Historic District Review Committee

Staff Report May 10, 2010

CAPP 2010-0002 Madison: New Residential Construction in the Waterford Historic District: PIN: 304-46-4671.

Photo 6: Typical brick jack arch on the Mahlon Schooley House on Second Street in the Waterford Historic District.

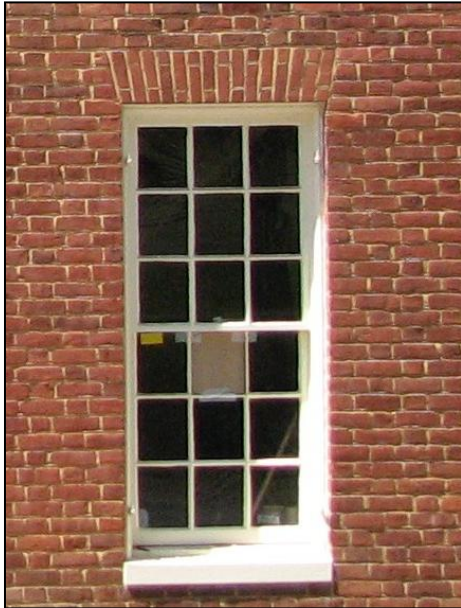
Additionally, the bricks should replicate the size, texture, and color of locally fired bricks used in the construction of historic buildings in the Waterford Historic District. Wire cut brick and artificially or chemically treated brick should not be used. The mortar should also match the texture and color, as well as the joint size and tooling, of historic precedents (*Waterford Guidelines, Guidelines for Materials: Stone and Brick, Inappropriate Treatment 7, Guidelines 2, 3, and 7, p. 123*).

The applicant supplied a brick sample and a photograph of mortar for the proposed chimney (Photo 8). The brick sample will be available for the HDRC to evaluate during the HDRC meeting. The brick is pressed, not wire cut, which meets the Guidelines. The color of the brick is also appropriate. The applicant may also refer to historic homes referenced in Table 1 or the neighboring Dunne Residence for brick color. However, the brick sample submitted is 8 ¾" by 4 ¼" by 2 ¼", which is oversized when compared with

historic bricks. Historical bricks are roughly 7 ½" by 3 ½" by 2" and bricks used for the main block should be this size.
